Technology Readiness Assessment Summary

United States Department of Energy Office of Environmental Management (DOE-EM)

Savannah River Site Tank 48H Waste Treatment Project

Typical WAO flow diagram

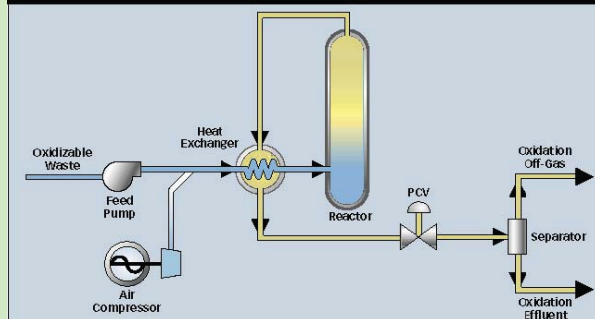
- Wet Air Oxidation Process:
 - Reactor system (TRL=3)
 - Offgas Treatment System (TRL=2)

- The reactor should undergo pilot-scale testing with simulants, laboratory-scale testing with actual wastes, and concept development to support design implementation.
- The offgas system should undergo laboratory and bench-scale testing with actual wastes (if practical). However, if using actual waste is not feasible in laboratory tests, offgas testing using tracers at commissioning should be considered.
